HUGHES SERVICE INFORMATION NOTICE

NOTICE NO N-62.1*
DATE August 4, 1971
PAGE 1 OF 6

SUBJECT: KIT - FLOOR BEAM REINFORCEMENT

MODELS AFFECTED: 269A Helicopter Serial Nos. 0011 thru 0884
269A-1 Helicopter Serial Nos. 0001 thru 0041
269B Helicopter Serial Nos. 0001 thru 0471

FIGURE 1. FLOOR BEAM REINFORCEMENT

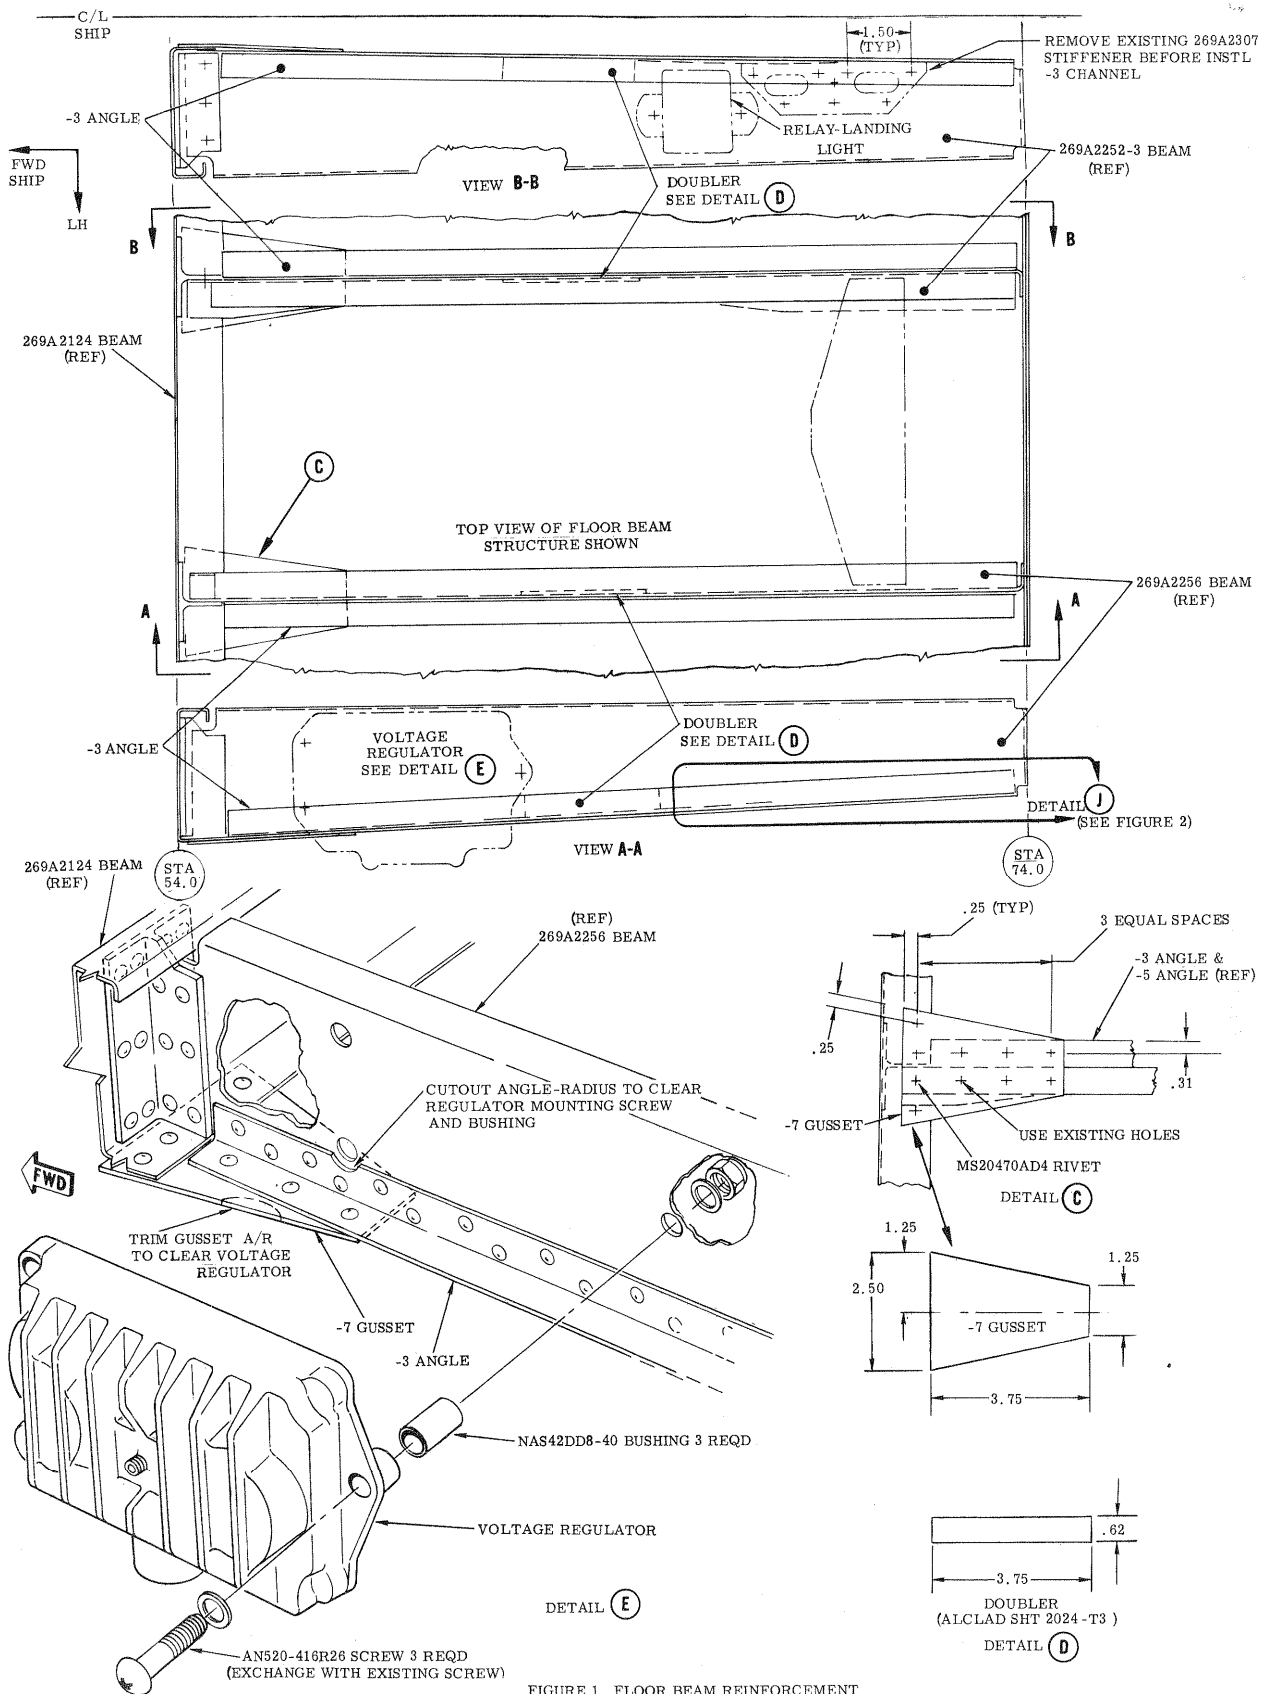
- a. Remove lower forward fairing; disconnect air filter inlet; cover carburetor/injector inlet to prevent entry of foreign objects.
- b. Remove landing light relay installed on 2252-3 beam (LH side) (Refer to Figure 1). or 2256 beam (RH side) (Refer to Figure 2). Also remove radio power supply unit, if presently installed on beams.

- c. Remove voltage regulator installed on 2256 beam (LH side). (Refer to Figure 1).
- d. Using #30 drill, remove rivets securing existing gussets at junction of 2124 and 2252-3 beams (2 places) and at junction of 2124 and 2256 beams (2 places).

j. Position -7 gusset (4 places) as shown at junction of 2124 and 2252-3 beams and 2124 and 2256 beams. Mark and drill holes in beams and install gussets with rivets. Use existing rivet holes in beams. (Refer to Figure 1).
